Operator: HIGHPOINT OPERATING CORPORATION

Location Name: Park 4-63-4 NE

Inspection: 699107965

Exhibit A

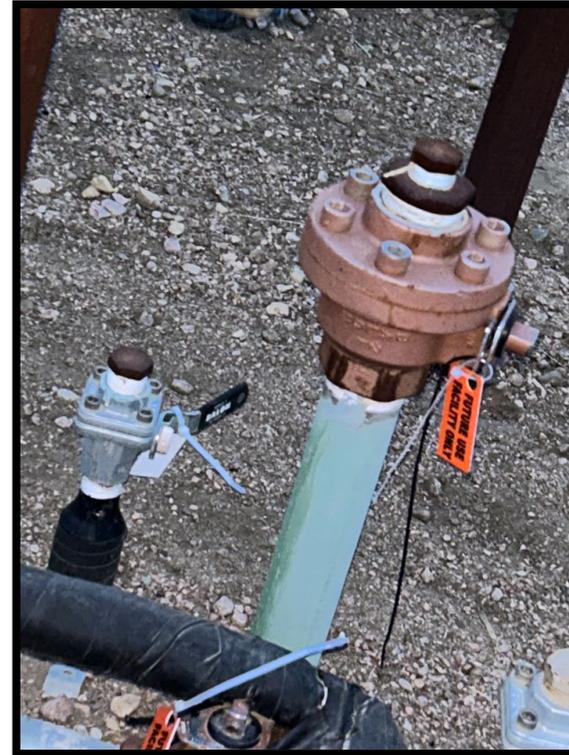
CA: Stained soil under appears to be leaking valve next to the lact needs to be removed. See attached photo. "Properly dispose of oily waste in accordance with 905.e."

CA Resolution: Operator has appropriately addressed and cleared identified stained soil to comply with Rule 905.e.
